35/13-04R 5806 Cedar Parkway
Chevy Chase Historic District

Master Bedroom Suite & Baths Remodeling

THE MARYLAND-NATIONAL CAPITAL PARK & PLANNING COMMISSION

FROM: Tania Georgiou Tully, Senior Planner
Historic Preservation

NEW FRENCH DOORS & WINDOWS ELEVATION

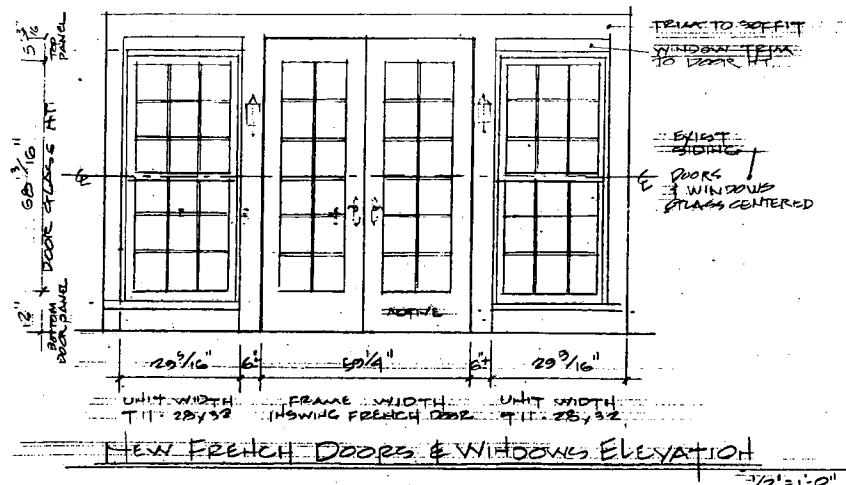
- verify windows - should be simulated divided light
